| VEHICLE MODEL | : TD925US, TDX25US |
| BULLETIN TYPE | : Field Change Program |
| DATE | : June 22nd, 2017 |
| SUBJECT | : To check position of rear junction box grid |

Figure 1: Location of rear junction box

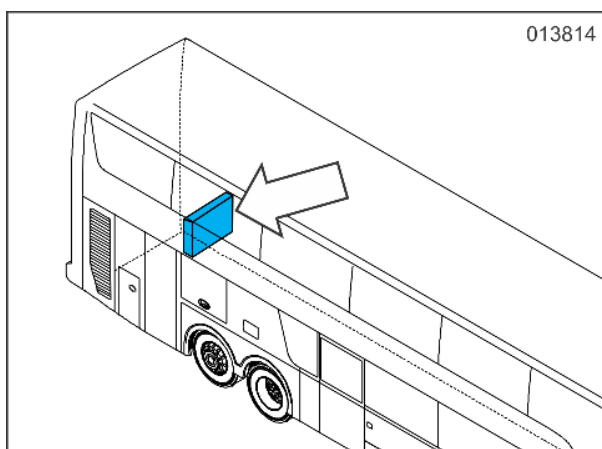
There is a possibility that the grid of the rear junction box is not properly positioned with respect to the surrounding covers. The side cover can prevent the circuit breakers from tripping off in case of an overload or shorted circuit. Owners and operators should first check the position of the grid, and change if necessary.

This Service Bulletin gives step-by-step instructions to reposition the rear junction box grid.

Figure 2: Rear junction box

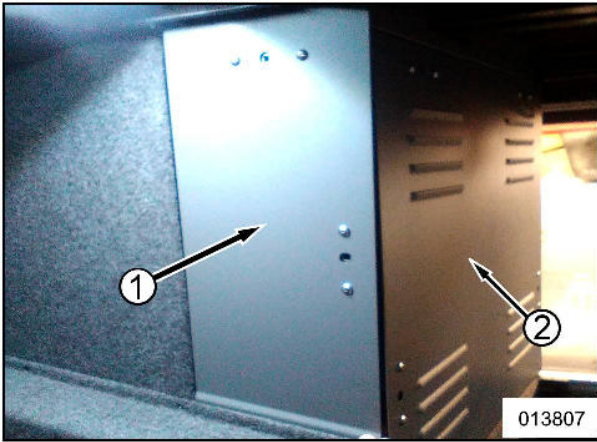
| <p>3</p> | <p>Check clearance “A” between side cover (1, figure 2) and circuit breakers.</p> <p>Is distance “A” less than 20 mm (0.7 inch)?</p> <ul style="list-style-type: none"> • If so, proceed with step 4. • If not, register through the registration button located behind Service Bulletin SB1438 on the Van Hool customer portal. Write the text "Junction box grid position checked, position OK" in the field "Remark". Labor allowance will only be awarded after Van Hool has received the registration. No further action is required. <div data-bbox="544 477 1142 913" data-label="Image"> </div> <p style="text-align: right;">013809 Figure 3</p> |

| <p>4</p> | <p>Reposition the junction box grid as follows:</p> <ol style="list-style-type: none"> Remove the screws securing the grid to the wall. Reposition the grid until the clearance between the circuit breakers and the side panel is sufficient. Secure the grid again. <div data-bbox="544 1149 1142 1585" data-label="Image"> </div> <p style="text-align: right;">013810 Figure 4: Position of grid fixing screws (example)</p> |
